**MEETING NOTICE AND AGENDA ZIONSVILLE PLAN COMMISSION MEETING  
Monday September 19, 2016**

**Petition Numbers:** 2016-37-PP & 2016-38-DP (Combined Summary Report)

**Subject Site Address:** 9085 E. Oak Street

To: Wayne DeLong, Director of Planning and Economic Development  
 From: Mark DeBruler, P.E., Town Engineer *md*  
 Date: August 22, 2016

RUSSELL LAKE  
OVERALL PLAN  
ZIONSVILLE, BOONE COUNTY, INDIAN  
JULY 26, 2015

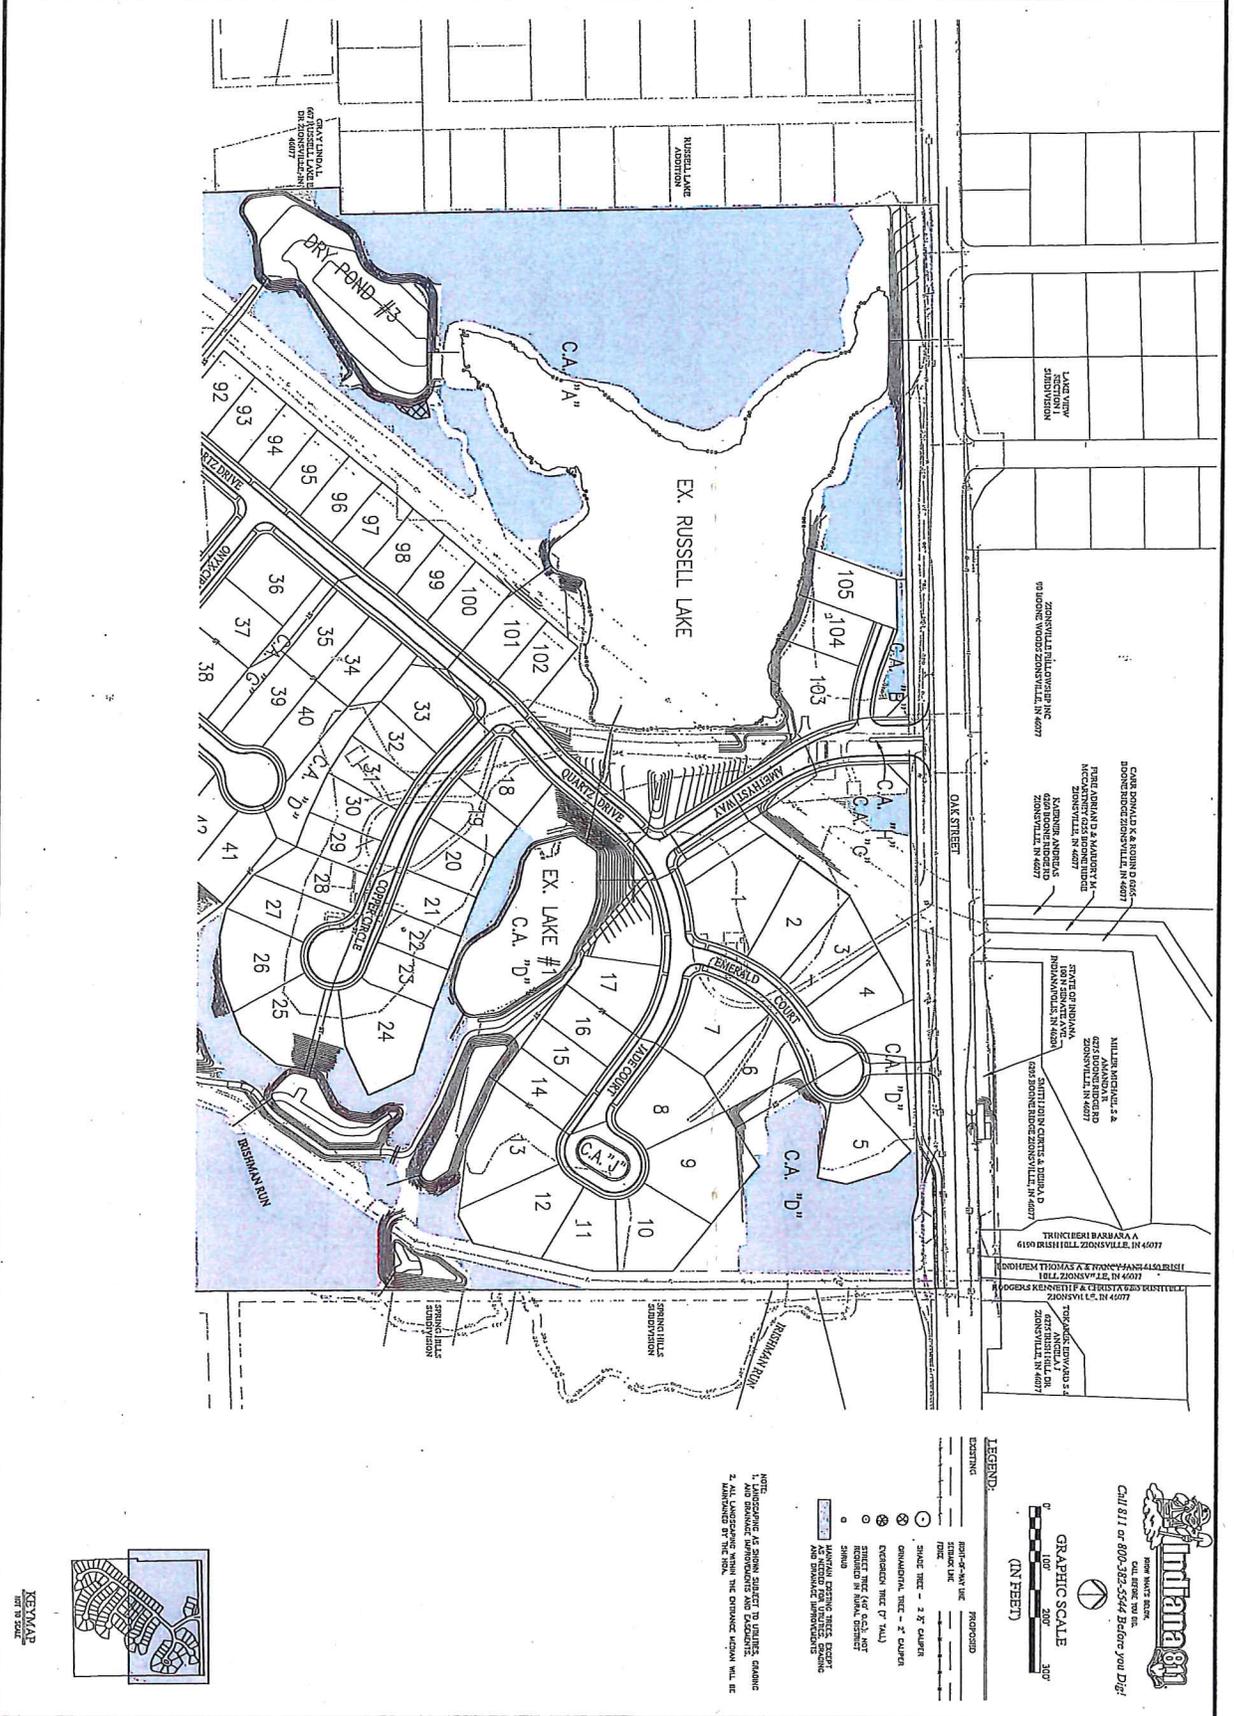
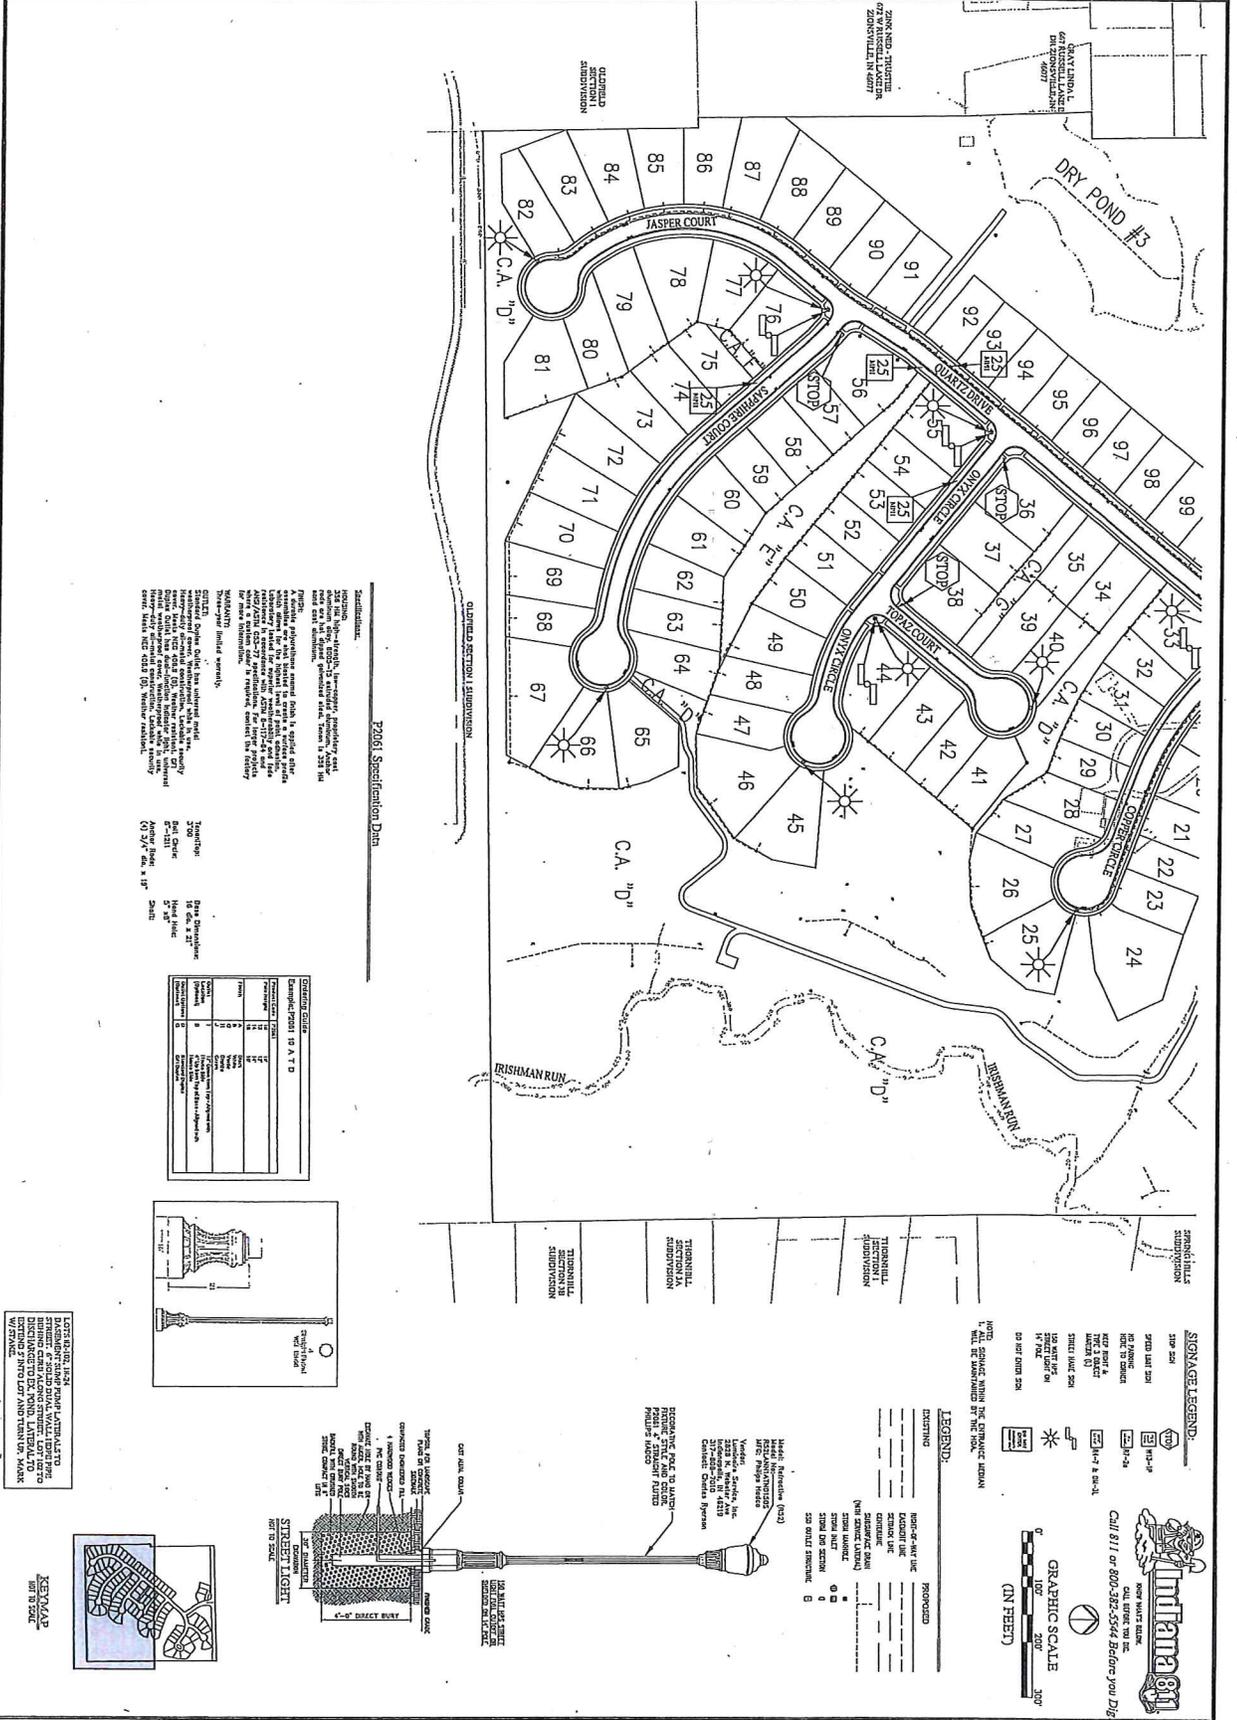
- A. Lot 1 is a triple-frontage lot. Please revise as these types of lots are not allowed.
- B. The Garnet Drive road spur to Lots 103-105 does not meet the standards for cul-de-sacs and is too close to the subdivision entrance to meet AASHTO intersection safety recommendations.

- C. Provide accel/decel lanes on Oak Street at Amethyst Way.
- D. The current BMP locations are inaccessible for maintenance. Relocate or otherwise revise the BMPs to be accessible by vehicles for maintenance.

- E. Obtain approval from the Oldfields homeowners for use of the easements on their property for the off-site storm sewer connection.
- F. There is a 20' Emergency Access Drive connecting Oak Street to Emerald Court. Provide a gated entrance with Knox box or other drive access security acceptable to Public Safety agencies.

- G. Provide an AutoTurn or similar vehicular path analysis showing the Fire Department's largest vehicle can negotiate the proposed turnaround at the end of Jade Court.

- H. Extend the Oak St. pathway to the property limits.
- I. Please provide additional detail on the stilling basin shown in the Dry Detention Basin with Infiltration Trench typical section shown on sheet C4.0.

**SQUIRES SUBDIVISION  
SHERIDAN, INDIANA  
MINOR RESIDENTIAL PLAT**

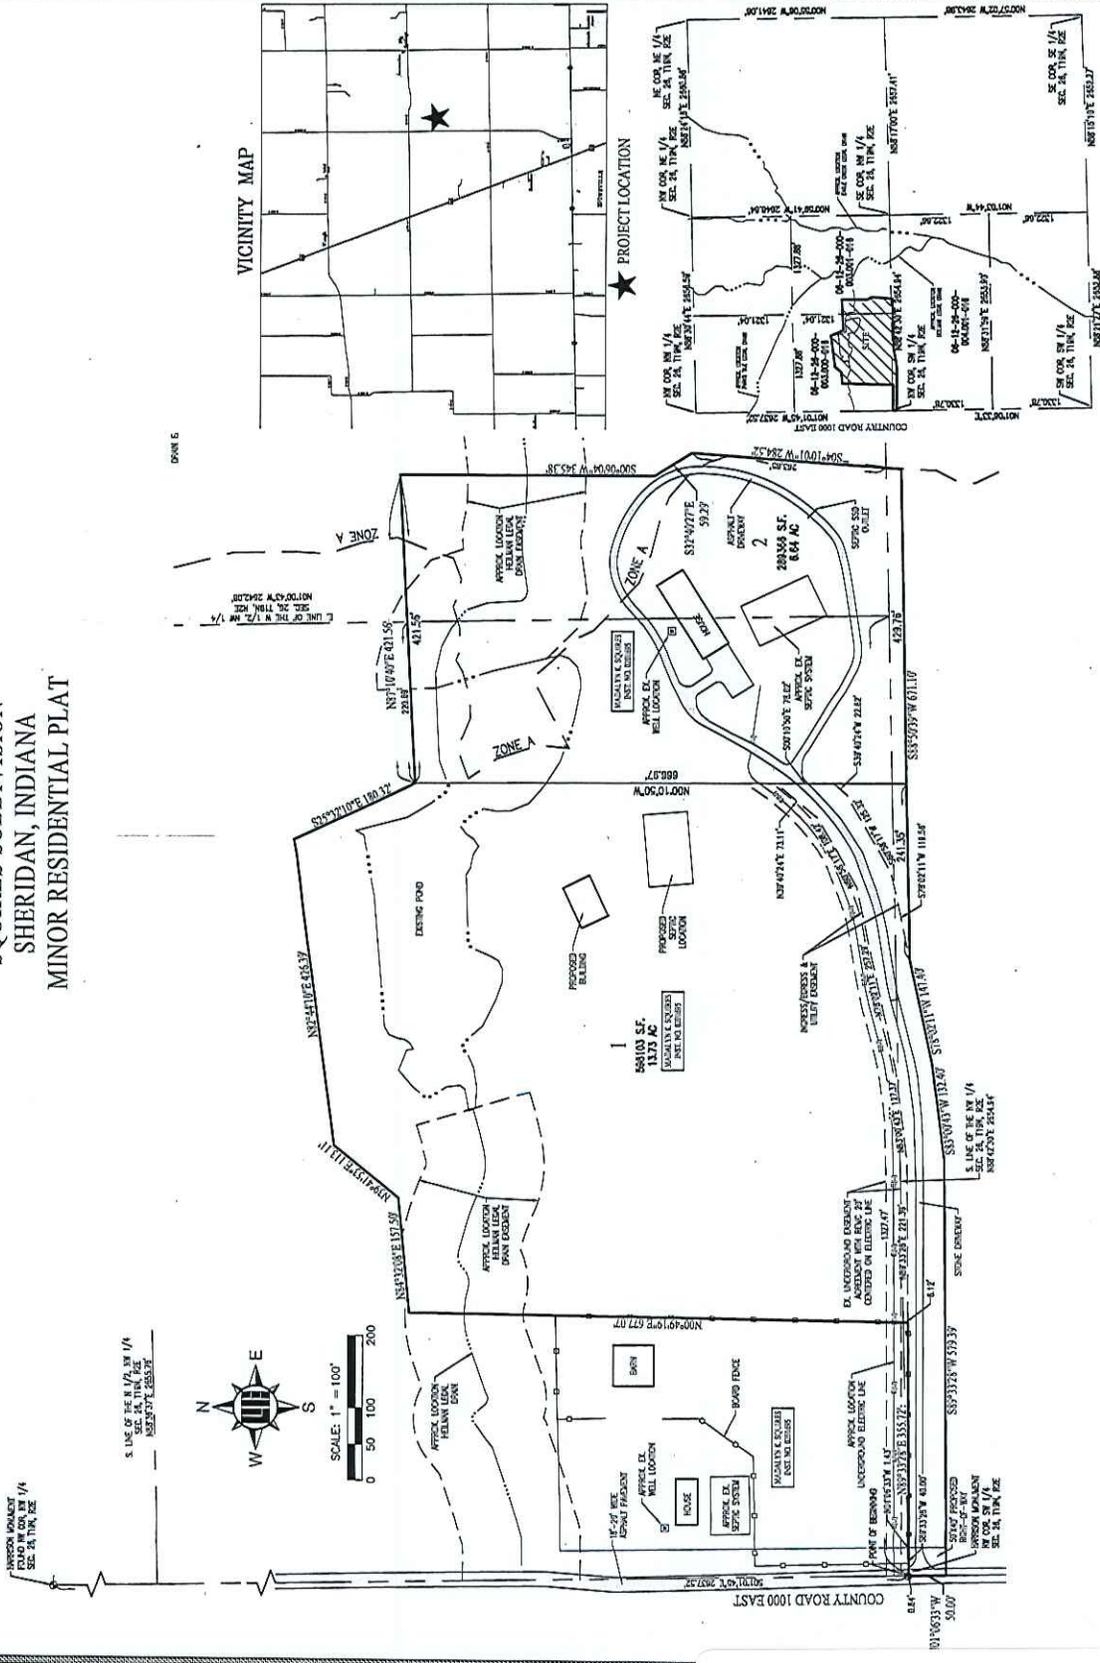
- A. Provide a statement about the existence of the Zone A floodway on the property, including source and extent of potential error in location.
- B. Please provide an address plan.
